**INDIVIDUAL EXPERT REPORT OF ROWENA SALMON
CONTAMINATION AND WASTE MANAGEMENT
4 AUGUST 2016**

**LIVERPOOL CITY COUNCIL V MOOREBANK
RECYCLERS PTY LTD AND MINISTER FOR
PLANNING, NSW LEC 2016/159652**

I have pleasure in submitting this expert report in relation to the proposed
Moorebank Waste Recycling Facility at Newbridge Road, Moorebank.

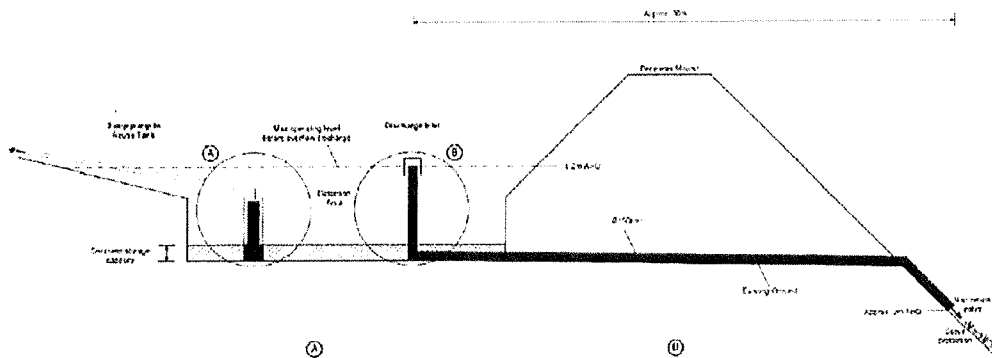
53. The proposed development stormwater drainage system includes boundary sumps which discharge through pipes that penetrate the base of the bunds (see figure below "General Sump Arrangement, Evans & Peck 2010"). This construction would create a potential pathway for landfill gas and leachate from the waste stored within the bunds, and could result in additional leachate generation if the stormwater discharge pipe fails within the bund. Therefore it is recommended that waste is not stored in the perimeter bunds to reduce the risk of landfill gas and leachate emissions from the bunds.
